FLORIDA POWER & LIGHT COMPANY

ST. LUCIE PLANT UNIT NO. 1

Amendment No. 18
License No. DPR-67

SAFETY EVALUATION BY THE OFFICE OF NUCLEAR REACTOR REGULATION

Figure 6.2-1 Offsite Organization for Facility Management and Technical Support

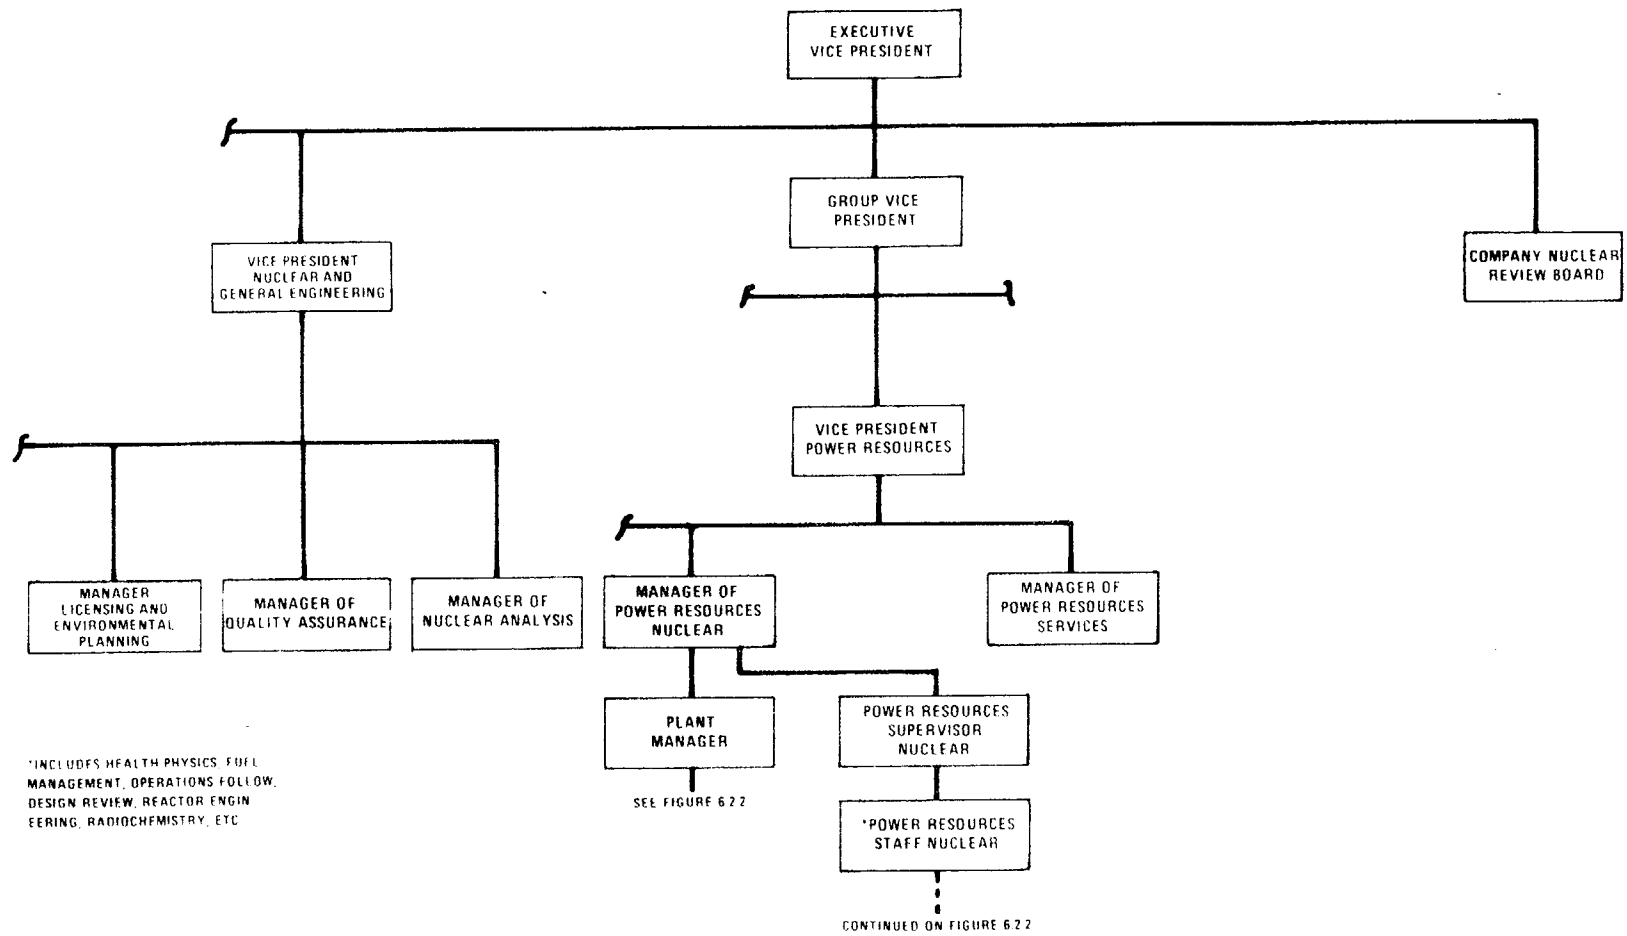
1. Modifies the Offsite Organization Chart to accommodate changes which are administrative in nature in accordance with your application dated September 6, 1977 (L-77-277),

By letter dated September 6, 1977, FPL proposed Technical Specifications changes to the Offsite Organization Chart. Proposed changes to figure 6.2-1 are as follows:

- a. New title -- Vice President
Nuclear and General Engineering
- b. New title -- Manager Licensing
and Environmental Planning
- c. Position deleted -- Vice President
Environmental Planning and Research

FPL states that the changes are not significant changes in the management or support of the FPL nuclear facilities; the responsibilities for research and environmental planning have been transferred to different people; and the changes have been reviewed by the St. Lucie Facility Review Group and the FPL Nuclear Review Board; and that the changes do not involve an unreviewed safety question.

Since the changes would not degrade operational plant safety, are administrative in nature, and would not affect the operation of either on-site or off-site safety review functions, the changes are acceptable.
